ADDENDUM NO. 01

SYRACUSE HANCOCK INTERNATIONAL AIRPORT

RECONFIGURE TAXIWAYS C, F, B, E, AND G

June 6, 2018

CONSTRUCTION SAFETY & PHASING PLAN (SHEET 3 OF 4)

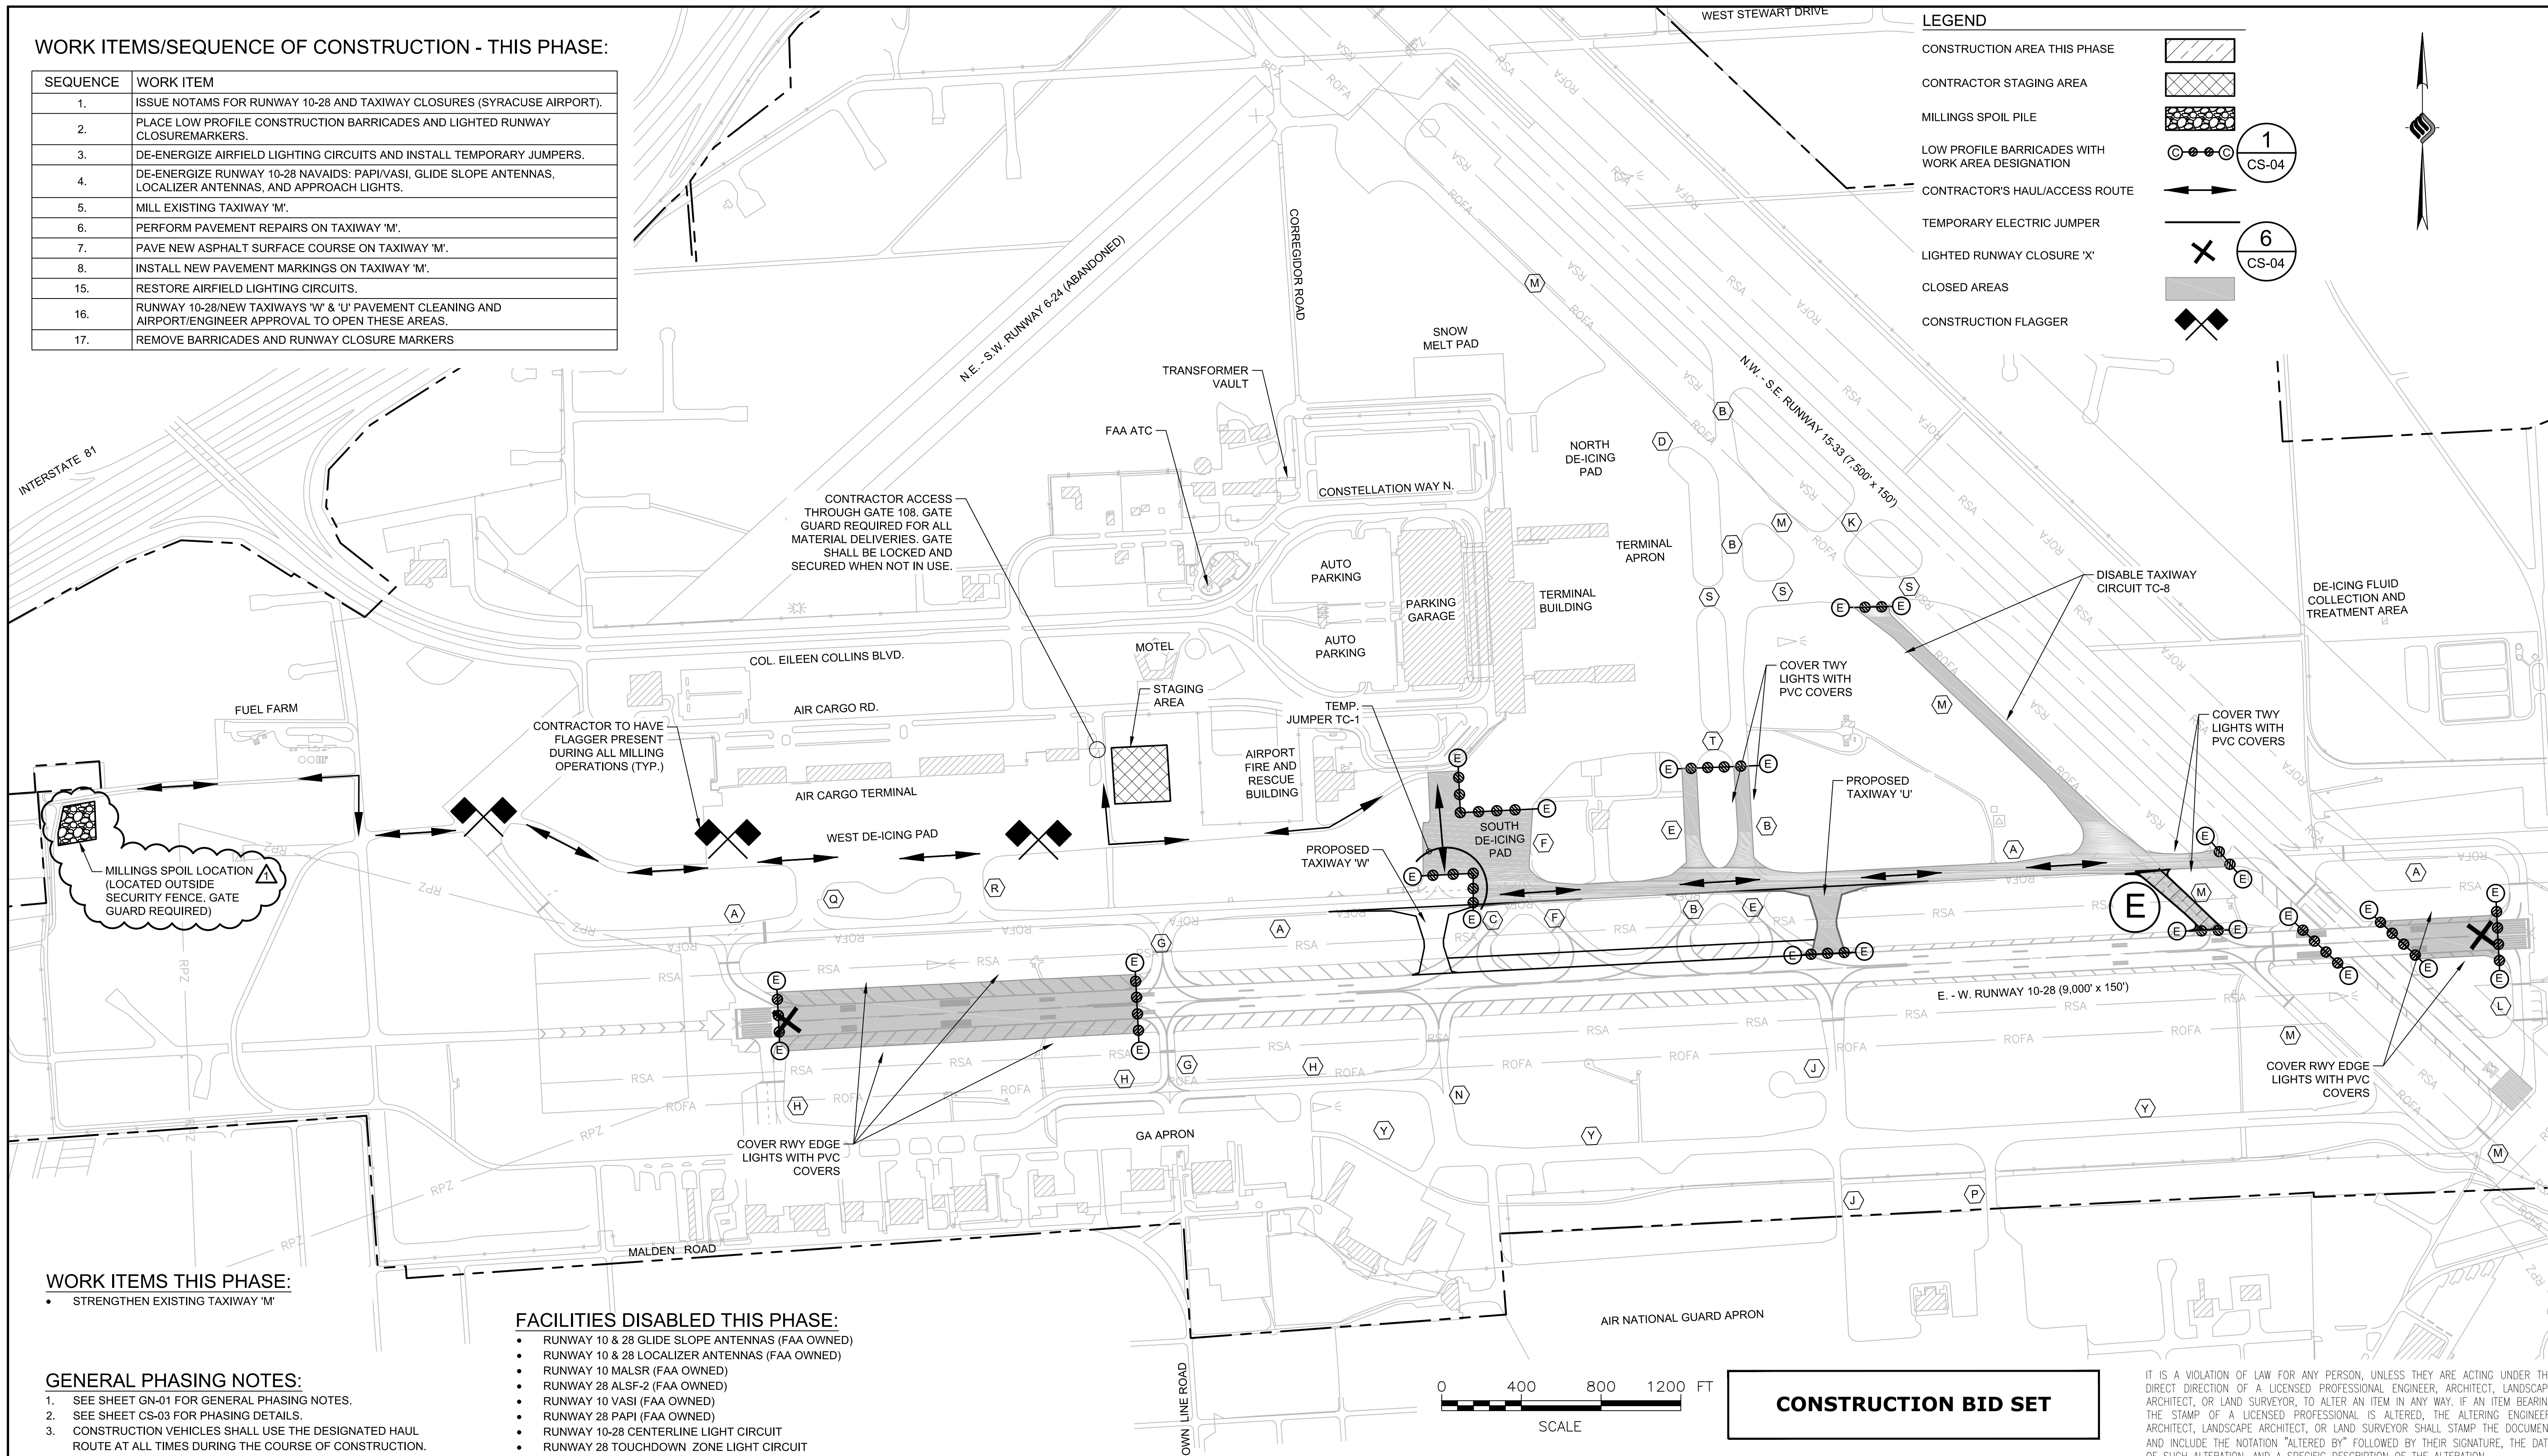
- d. CS-03 CONSTRUCTION SAFETY & PHASING PLAN (SHEET 3 OF 4)
 - i. Added note to clarify location of milling stockpile. Stockpile is located outside of the airport security fence and will require a gate guard during hauling operations.

CONSTRUCTION SAFETY & PHASING PLAN (SHEET 4 OF 4)

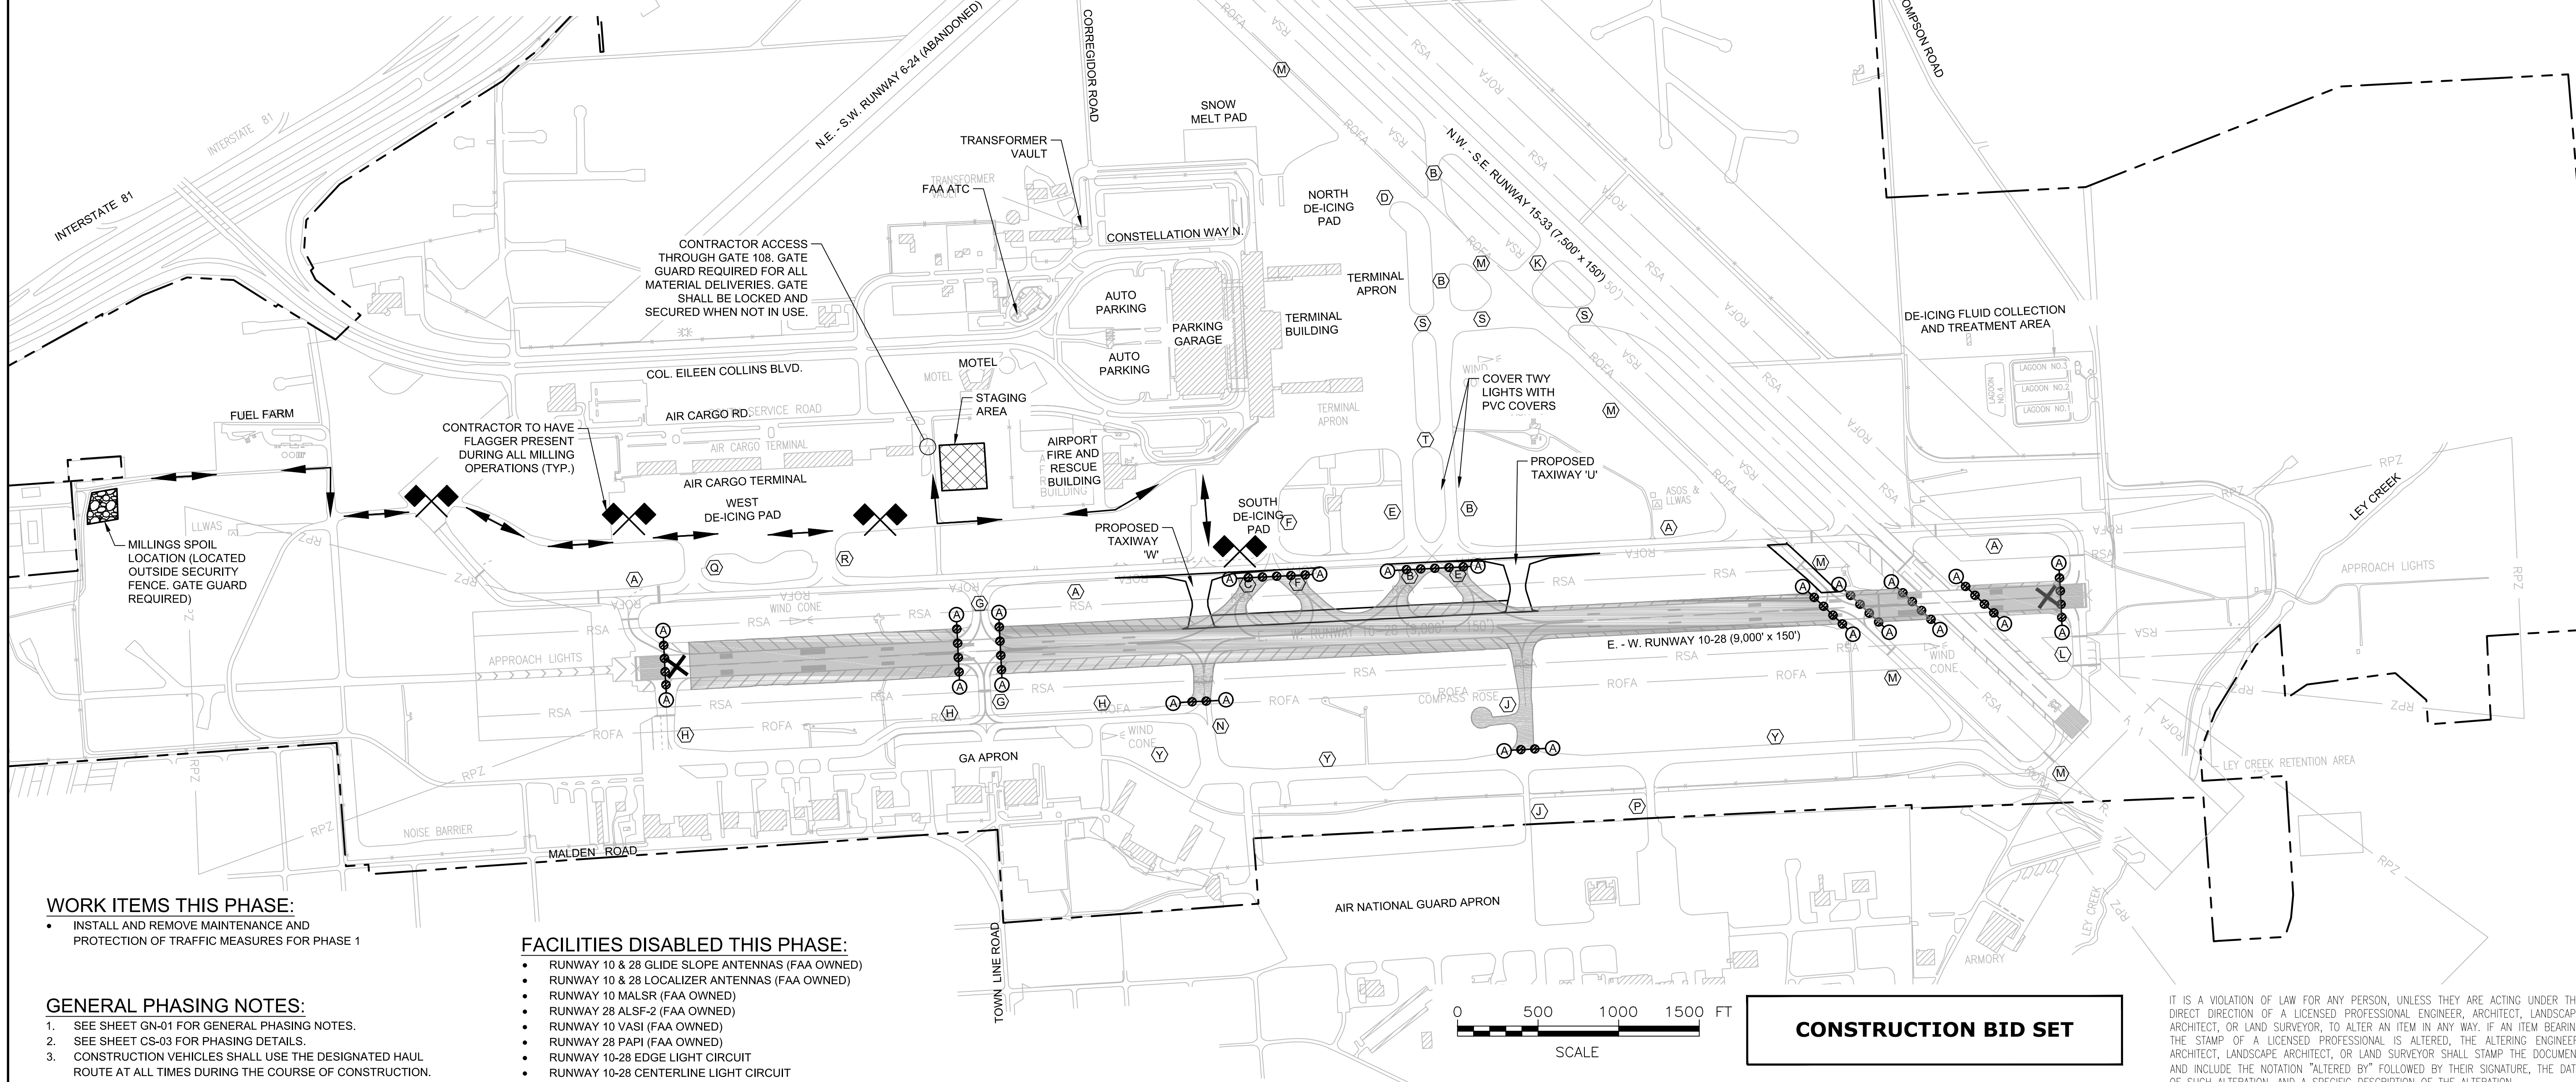
REV	DATE	DESCRIPTION	BY
1	6/6/2018	ADDENDUM NO. 1: ADDED WORK AREA FOR PHASE 1	JPM
		MPT INSTALLATION AND REMOVAL

UNDERCUT EXCAVATION AND BACKFILL TYPICAL SECTION 4

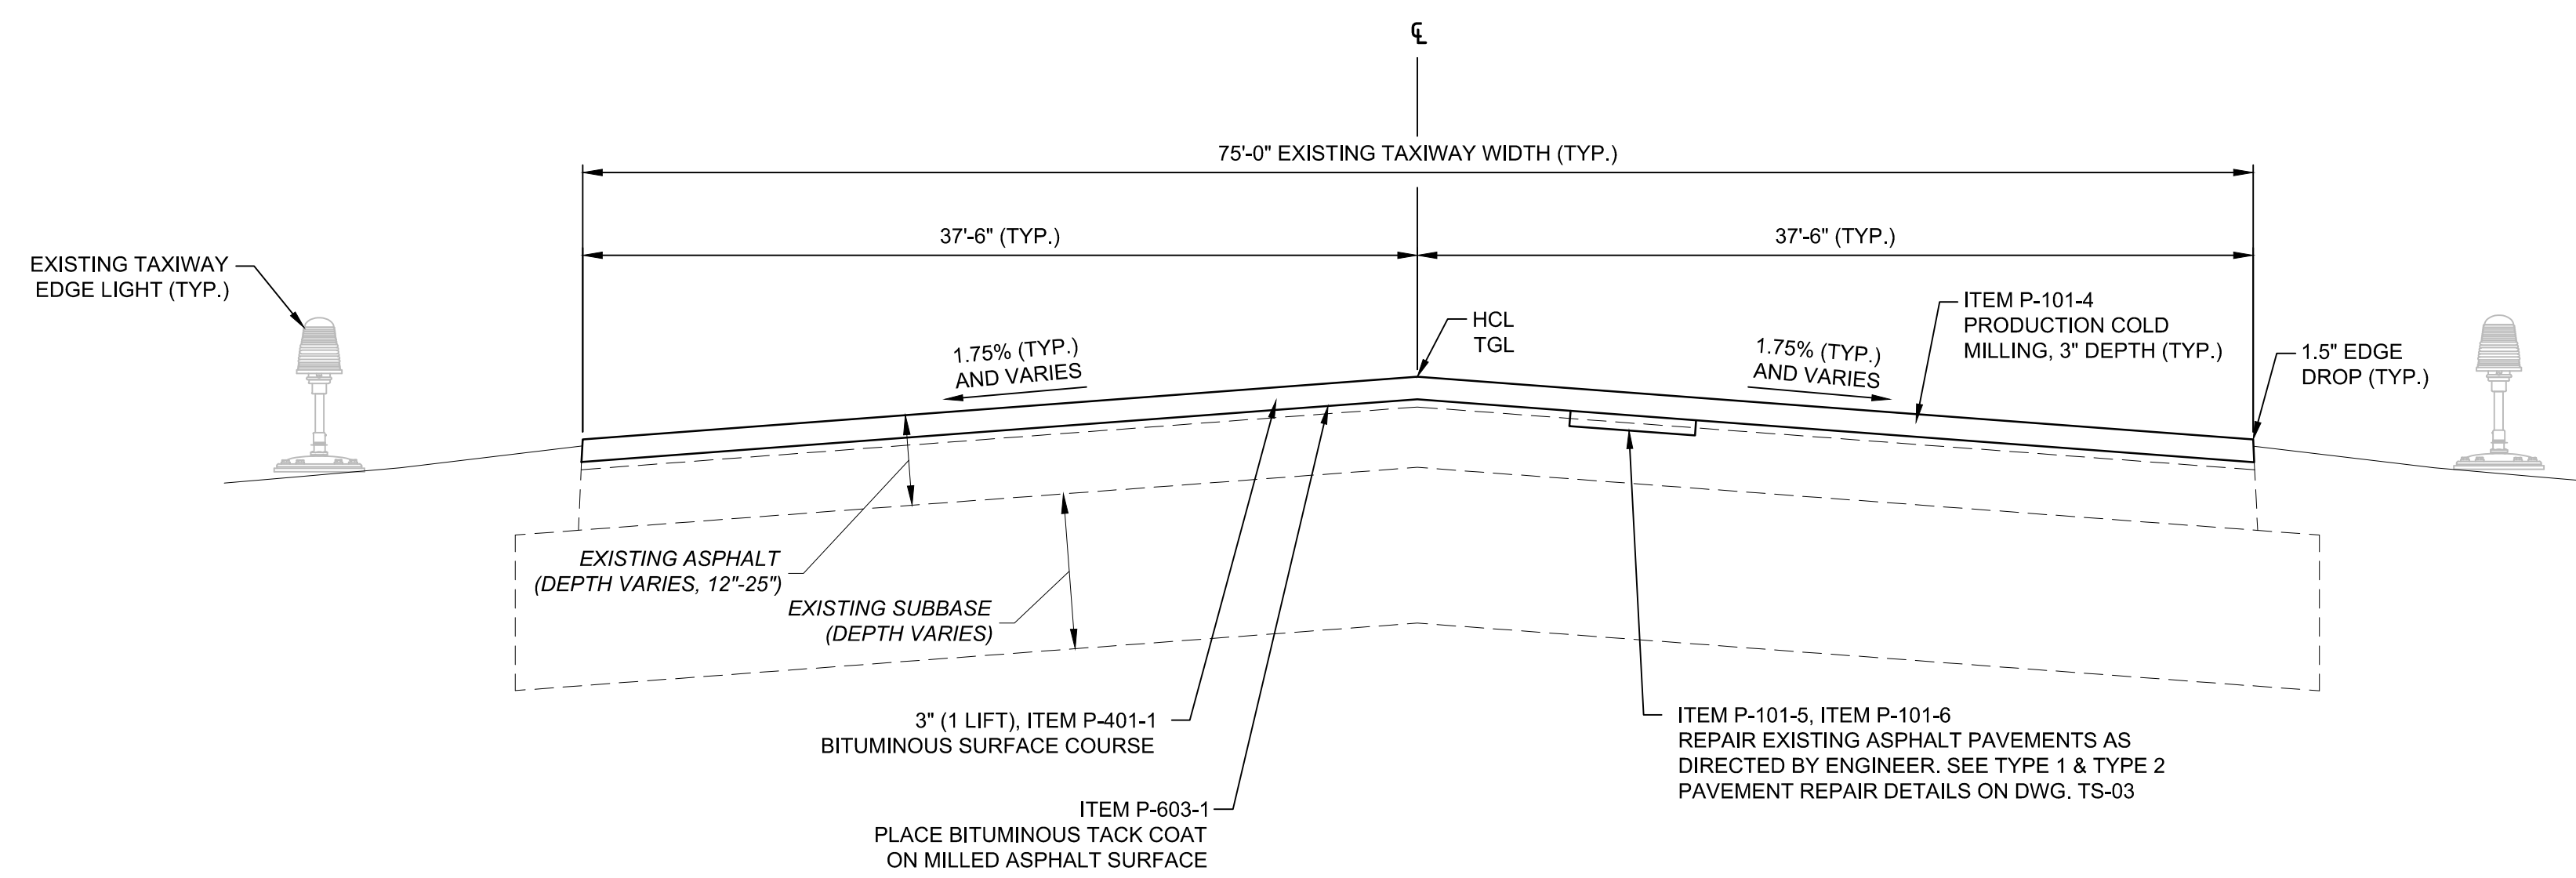
- e. TS-02 TYPICAL SECTIONS – 2
 - i. Added detail for Undercut Excavation and Backfill.
 - f. GR-01 GRADING & DRAINAGE PLAN (SHEET 1 OF 4)
 - i. Added existing contour labels.
